SOUTHEASTERN FREIGHT LINES PARK **SUBDIVISION, ADDITION TO**

Engineering Comments: FINAL PLAT COMMENTS (should be addressed prior to submitting the FINAL PLAT for review and/or signature by the City Engineer):

APPLICATION NUMBER 4 DATE November 17, 2022

DETAIL SITE PLAN

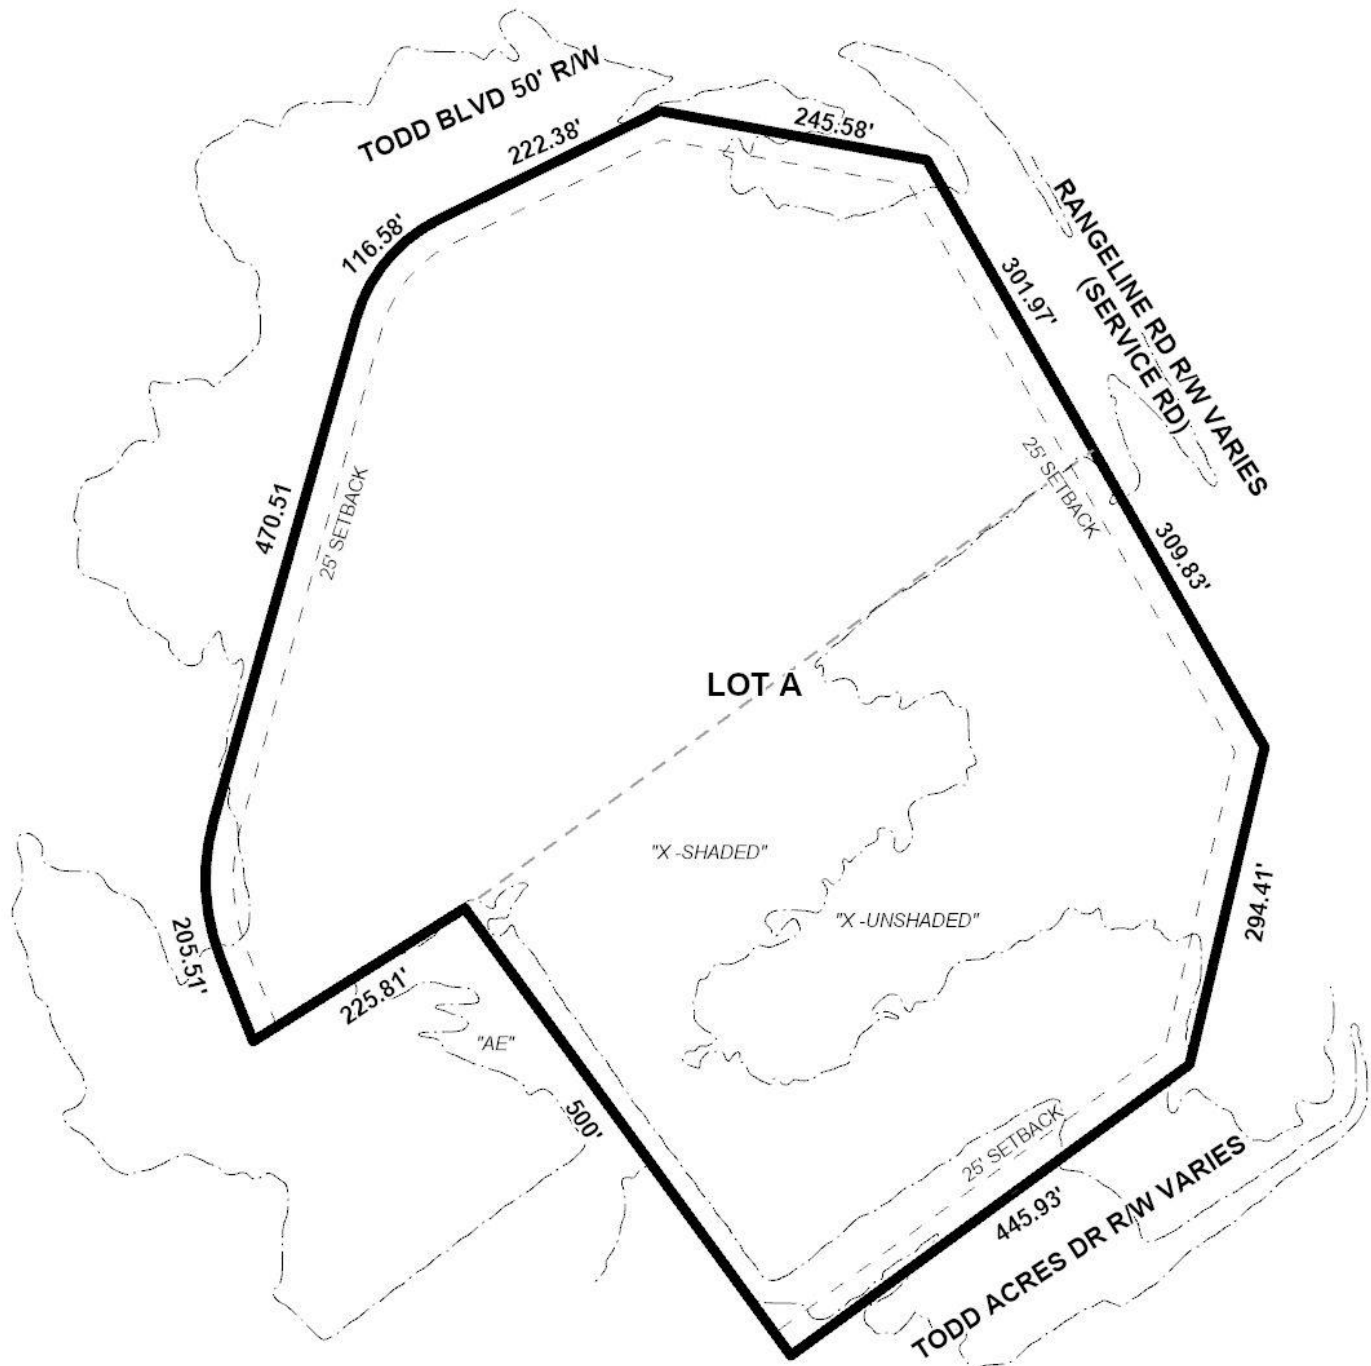
In accordance with the Subdivision Regulations, the proposed lot exceeds the minimum size requirements, and the lot is labeled with its size in both square feet and acres on the preliminary plat. The lot size label should be retained on the Final Plat, if approved, or a table should be furnished on the Final Plat providing the same information. The plat illustrates the 25-foot minimum building setback line along all street frontages, and this should also be retained on the Final Plat, if approved.

The recorded plat of Todd's Commercial Park Subdivision indicates a ten (10)-foot buffer planting strip along the Todd Boulevard frontage, as measured from the right-of-way line. This was required on the 1996 approval of that subdivision, and this should be illustrated on the Final Plat of the current subdivision, if approved.

The proposed lot fronts Rangeline Road, Commerce Boulevard East, and Todd Boulevard. Rangeline Road is a major street according to the Major Street Plan component of the Comprehensive Plan, with a planned 300-foot right-of-way. The preliminary plat indicates a varying right-of-way width for Rangeline Road, but City GIS data indicates the right-of-way exceeds 300 feet along Rangeline Road; therefore, no dedication should be required. Commerce Boulevard East is a minor street with the plat indicating a varying right-of-way width. As the City GIS data indicates a right-of-way width of approximately 370 feet for Commerce Boulevard East along its front, no dedication would be required. Todd Boulevard is a minor street without curb and gutter with a 50-foot right-of-way. A 60-foot right-of-way is normally required for minor streets without curb and gutter; however, as no dedication was required along Todd Boulevard with the approval of Todd's Commerce Park Subdivision, none should be required for the subdivision at hand, if approved. All street name labels and right-of-way width labels should be reflected on the Final Plat, if approved.

No easements are indicated on the preliminary plat. If easements are to be indicated on the Final Plat, a note should be required on the Final Plat to state that no structures may be placed or constructed within any easement without the permission of the easement holder.

parking. As only one building will remain on the proposed one lot, no Planned Unit Development would be required for the site. However, demolition permits should be obtained for all structures, except the primary structure, prior to the signing of the Final Plat.

- 1) retention of the lot size label in both square feet and acres on the Final Plat, or the furnishing of a table on the Final Plat providing the same information;

- 2) retention of the 25-foot minimum building setback line along all street frontages on the Final Plat;
- 3) revision of the plat to indicate a ten (10)-foot buffer planting strip along Todd Boulevard, as measured from the front property/right-of-way line, within the 25-foot minimum building setback, as required on the 1996 plat of Todd's Commercial Park Subdivision;

- 4) illustration of the street name labels and right-of-way widths of all streets on the Final Plat;
- 5) if easements are indicted on the Final Plat, a note should be placed on the Final Plat stating that no structures may be placed or constructed within any easement without the permission of the easement holder;

- 6) demolition of all structures, except one, with appropriate permits, prior to signing the Final Plat;
- 7) compliance with the Engineering comments: *(FINAL PLAT COMMENTS (should be addressed prior to submitting the FINAL PLAT for review and/or signature by the City Engineer): A. Provide all of the required information on the SUBDIVISION PLAT (i.e. signature blocks, signatures, certification statements, written legal description, required notes, legend, scale, bearings and distances) that is required by the current Alabama State Board of Licensure for Professional Engineers and Land Surveyors. B. Add a note to the SUBDIVISION PLAT stating that as shown on the 1984 aerial photo LOT A will receive historical credit of existing (1984) impervious area towards stormwater detention requirement per Mobile City Code, Chapter 17, Storm Water Management and Flood Control) as follows: LOT A – NONE. C. Add a note that sidewalk is required to be constructed, and/or repaired, along the frontage of each lot, or parcel, at time of new development or construction, unless a sidewalk waiver is approved. D. Revise NOTE #8 to read "All existing and proposed detention facilities, common areas, and wetlands shall be the responsibility of the Property Owner(s), and not the responsibility of the City of Mobile." E. Add a note that all easements shall remain in effect until vacated through the proper Vacation process. F. Email a pdf copy of the FINAL SUBDIVISION PLAT and LETTER OF DECISION to the Permitting Engineering Dept. for review at land.disturbance@cityofmobile.org prior to obtaining any signatures. No signatures are required on the drawing.);*
